UNITED STATES PATENT AND TRADEMARK OFFICE

| APPLICATION NO. | FILING DATE | FIRST NAMED INVENTOR | ATTORNEY DOCKET NO. | CONFIRMATION NO. |
|--|-------------|--------------------------|---------------------------|------------------|
| 09/480,584 | 01/10/2000 | Stephen Edward Hettinger | 9D-HR-19167-HETTINGER | 4498 |

Office Action Summary

Cunningham seal 62 endcompassing the endcap 64 of the housing.

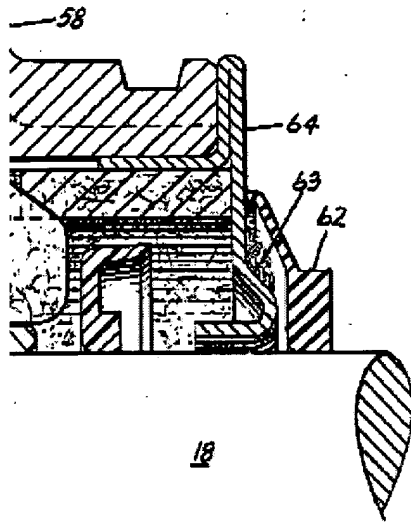
3. The rejection of Claims 1, 2, 4, 5, 8, 11, and 13 over Otto is withdrawn.
4. Claims 1, 4, 8, 10, 11, and 14 are rejected under 35 U.S.C. 102(b) as being clearly anticipated by Cunningham (US 3885176). Cunningham teaches a shield 62 having a cylindrical shroud encompassing a portion of the bearing housing 64 (inherently part of the motor housing), and a hub which obstructs the opening in the shroud to prevent dirt from getting into the motor. Cunningham teaches the opening and the hood both are positioned along the shaft axis. Cunningham teaches the seals 61 engaging the shaft sufficiently tightly to rotate therewith. Cunningham teaches the hub and shroud are integrally molded, and adapted to flex around the shaft.

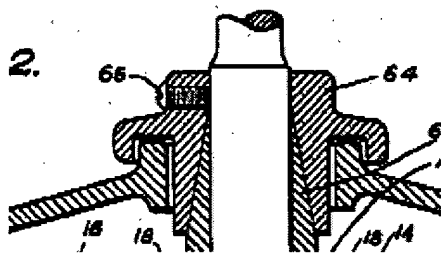
5. The rejection of Claims 1, 4, 5, and 8-10 are rejected under 35 U.S.C. 102(b) as being clearly anticipated by Else (US 1992818). Else teaches a shield 29 having an shroud 32 and a hub which obstructs the opening in the shroud to prevent dirt from getting into the motor. The hub being tapered the center of the opening to mate with a collar 63 on the shaft. Else teaches the hub and shroud are integrally formed.

Else shows the hub portion at 64 secured to the shaft with a hood portion extending opposite the hub and enclosing a portion of the house 61. The hub portion being frustroconical to mate with the collar 63 on the shaft, which prevents dust and dirt from getting into the housing (col. 2, line 15).
